**Addendum No. 1  
September 27, 2021**

Project: **Harrisburg Middle School No. 3**  
Harrisburg, South Dakota  
Architecture Incorporated Project #2903

Architect: Architecture Incorporated

1  
A108 - WEST ELEVATION  
4.53 SCALE: 1/4" = 1'-0"

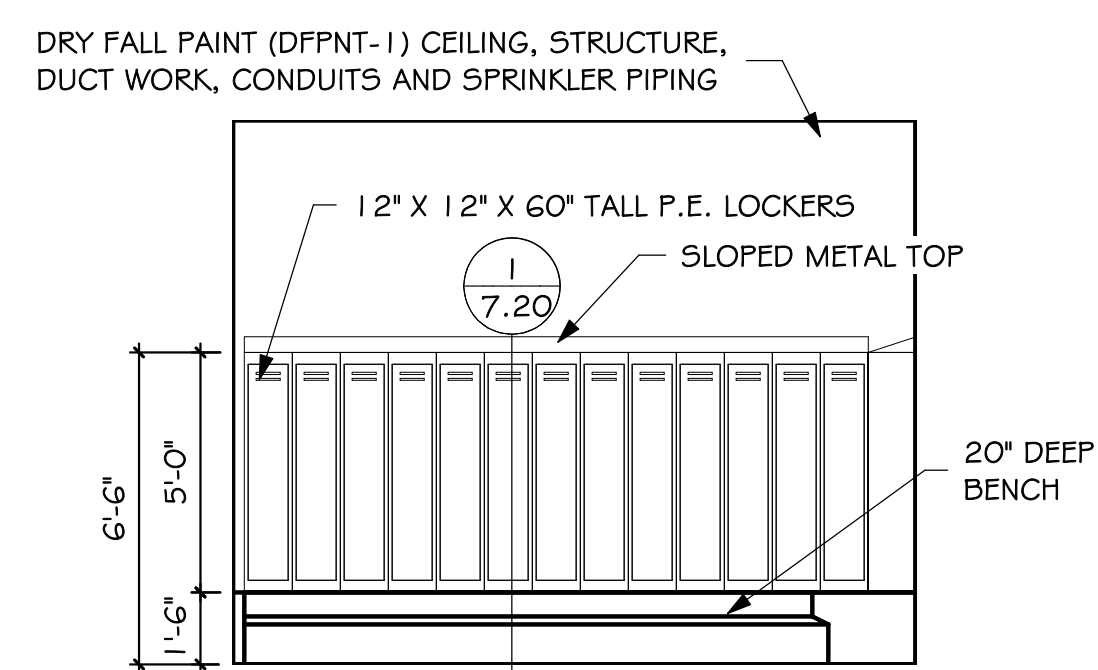
- a) 1 /4.53 – A108 WEST ELEVATION:
  - i) Raise the bottom of all tectum wall panels to 15'-0".
  - ii) The painted mural by Owner will be centered above the basketball backstop.
  - iii) Disregard / omit the 8' x 6' rectangle located between the 4<sup>th</sup> and 5<sup>th</sup> precast panels from the south.
- b) The Contractor shall furnish and install 12" x 12" x 60" metal lockers at locations where 12" x 12" x 15" (4 tier) lockers were originally identified; reference interior elevations 2, 3, 4, 6, 7 & 8 / 4.53.
  - i) See revised architectural drawing Sheet 4.53, revision dated 9-27-21, attached to the end of Addendum #1 for additional information.

**SD1**

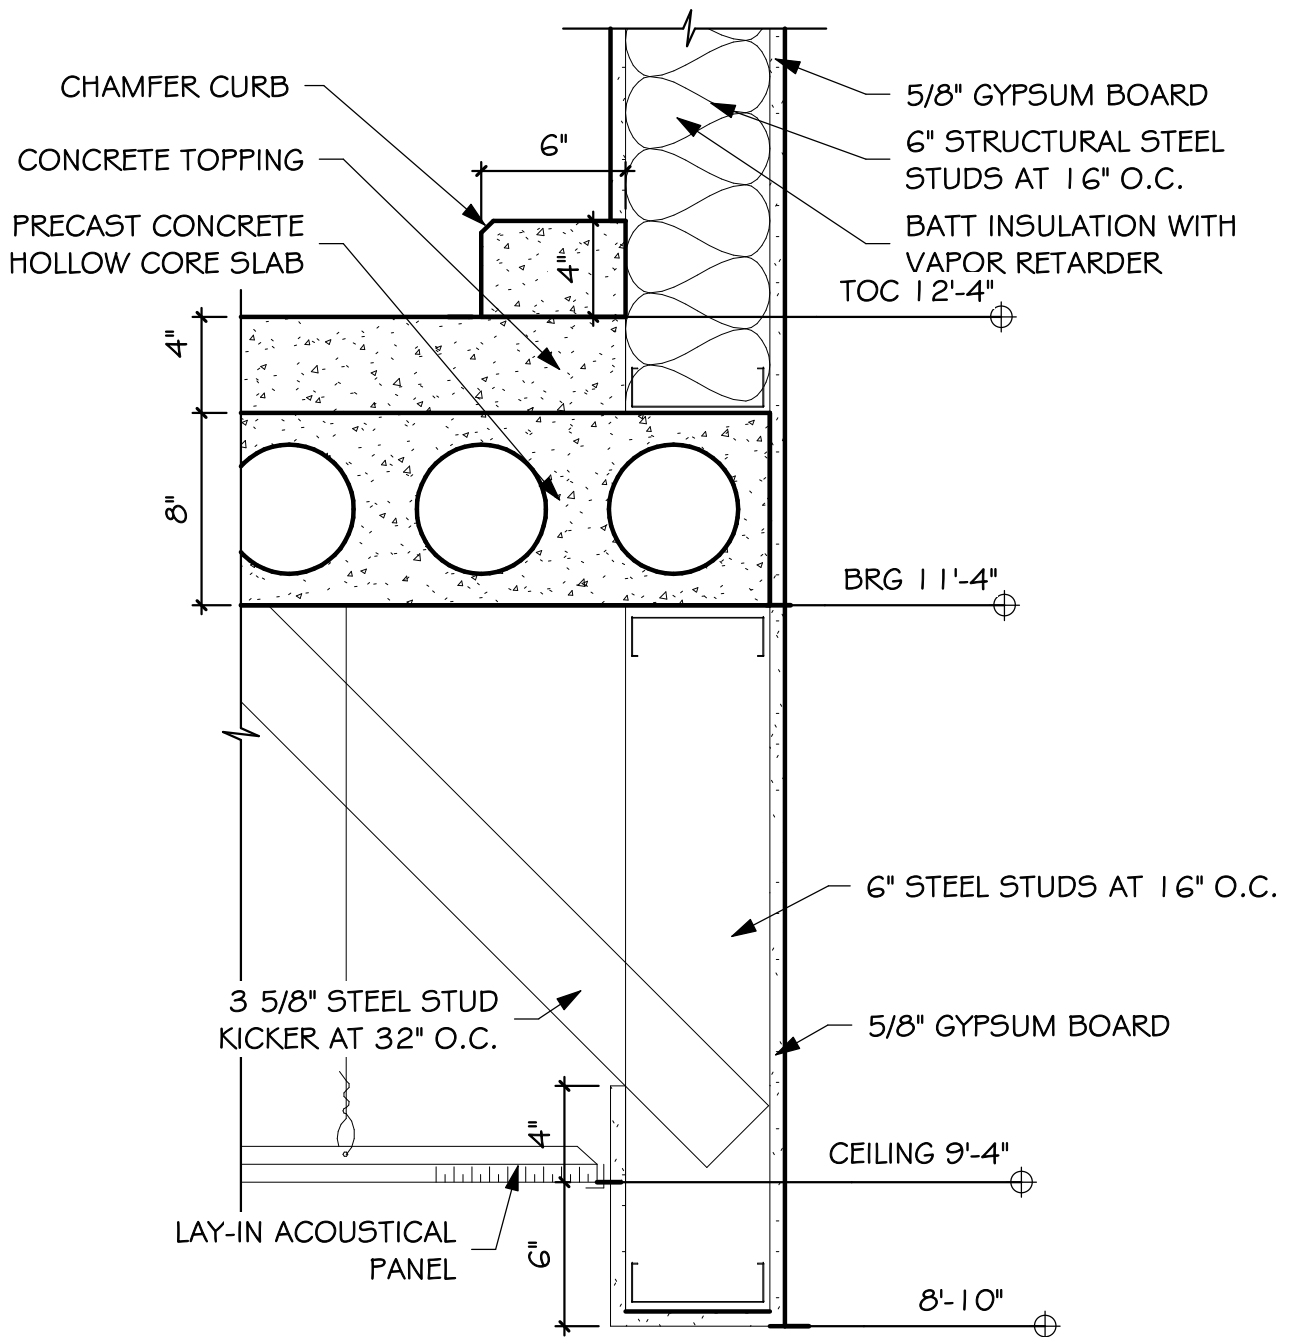
- a) Detail 5/5.42: Reference Structural Detail 6/3.62 for typical joist bearing section.
- b) Revised Detail 6/5.42: Reference SD1 , dated September, 2021, attached to the end of Addendum #1.
- c) Detail 7/5.42: Add note “***1-5/8” STEEL STUDS AT 16” O.C.***” at each side of beam for attachment of gypsum board.

## SD2

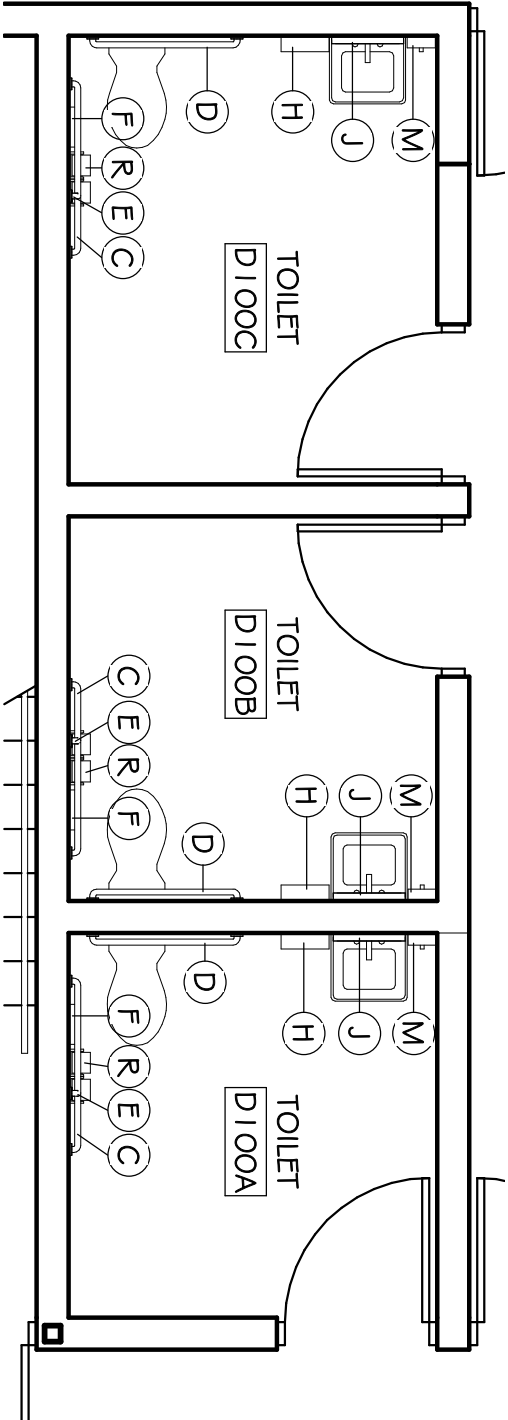
- a) Detail 4/5.45: Change corefloor bearing to 11’-4”. The finished floor elevation of the penthouse shall be 12’-4”.
- b) Detail 4/5.45: The finished floor elevation of the penthouse shall be 12’-4”.
- c) Revised Detail 5/5.45: Reference SD2, dated September 27, 2021, attached to the end of Addendum #1.

**SD5**

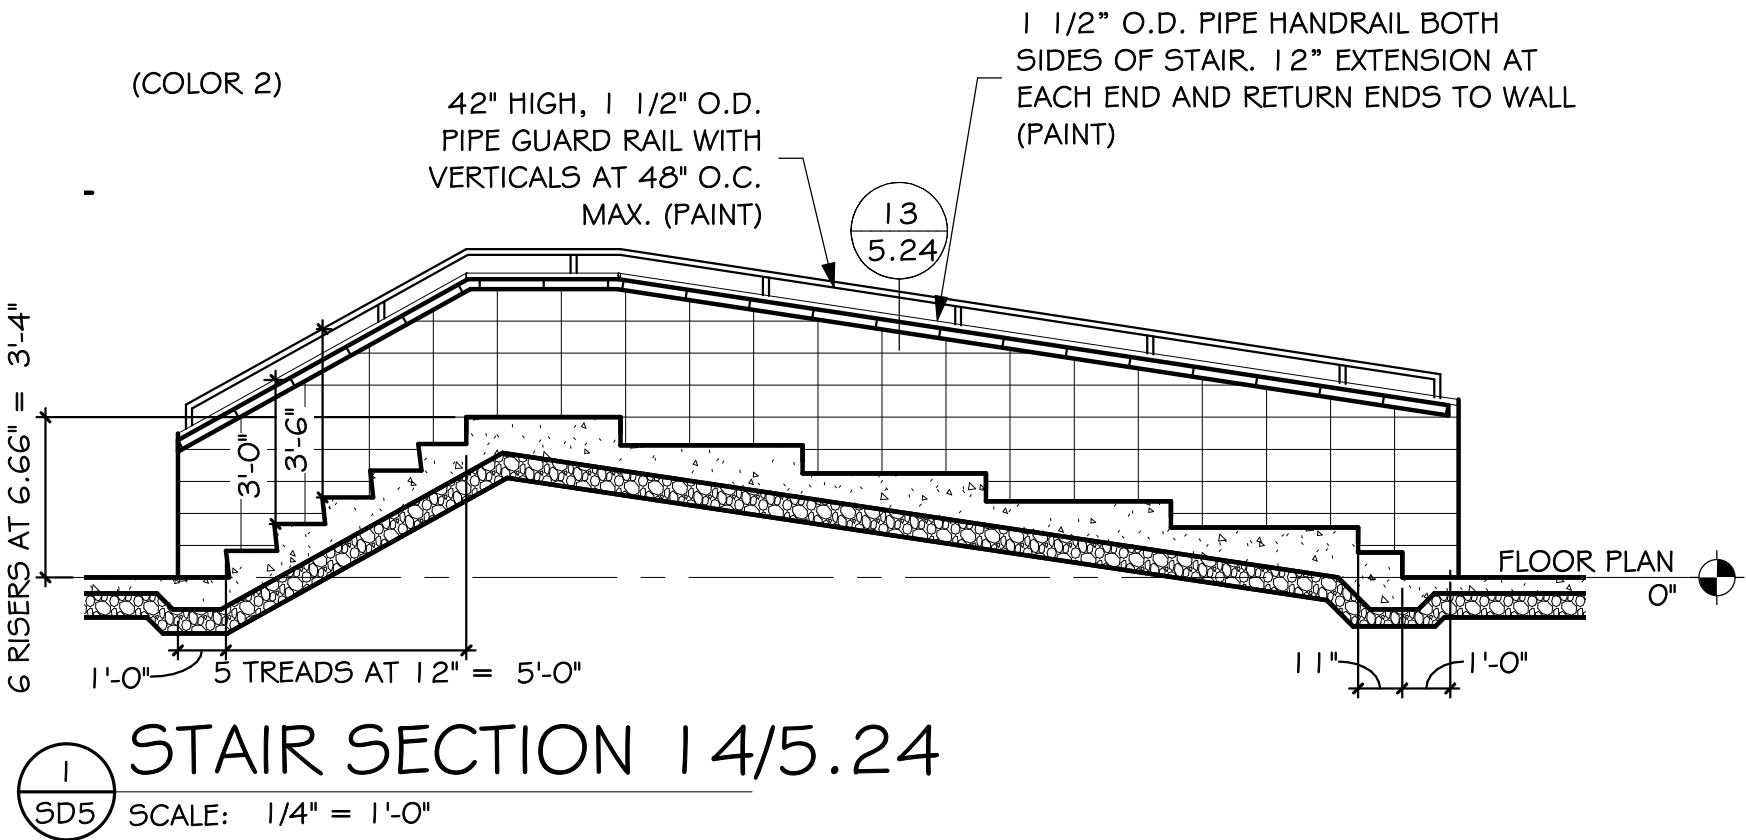
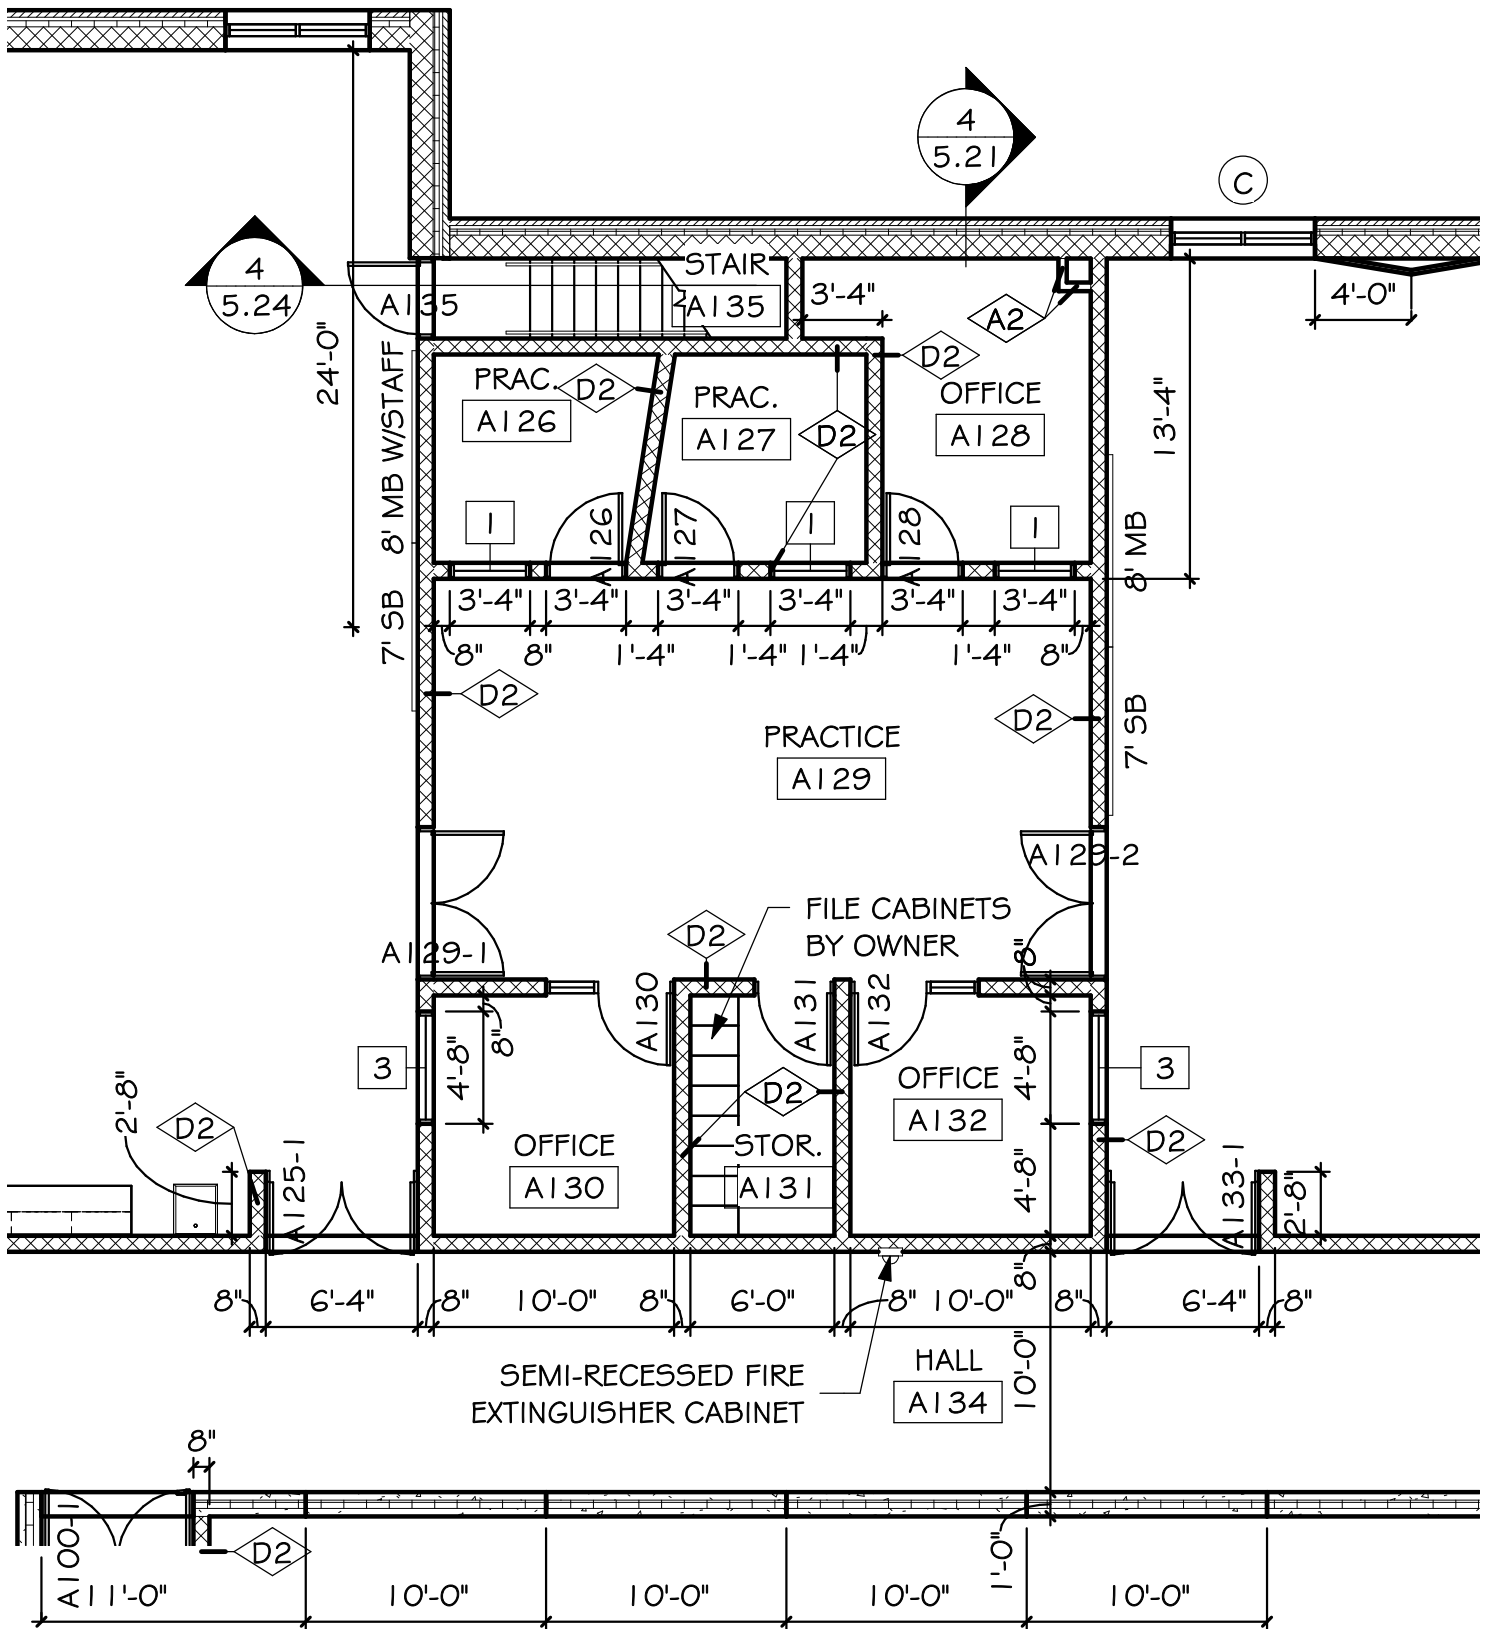
- g) Provide continuous wall-mounted steel pipe handrails along the Type D2 masonry walls that flank upper seating rows K thru R in Auditorium A102.
- i) Reference supplemental drawing SD5, dated September 27, 2021, attached to the end of this addendum for additional information.

- d) Provide continuous wall-mounted steel pipe handrails along the Type D2 masonry walls that flank upper seating rows K thru R in Auditorium A102.
  - i) Reference supplemental drawing SD5, dated September 27, 2021, attached to the end of this addendum for additional information.
